■ Specification and Appearance Differences Due to Specification Changes

<Specification change details>

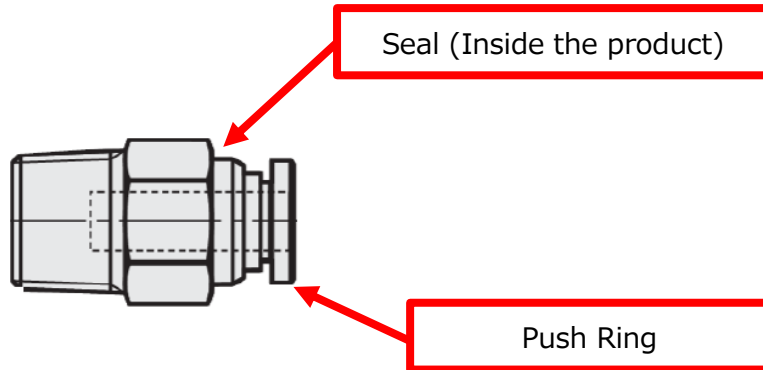
No.	Change Details	Before Change	After Change
①	Material (Push Ring)	PBT (Polybutylene Terephthalate)	POM (Polyacetal)
②	Material (Seal)	Fluoro Rubber	NBR (Nitrile Rubber)
③	Exterior Color (Push Ring)	Light blue	Blue
④	Exterior Engraving (Push Ring)	Manufacturer Brand	MiSUMi

※There is no change in function due to the material change.
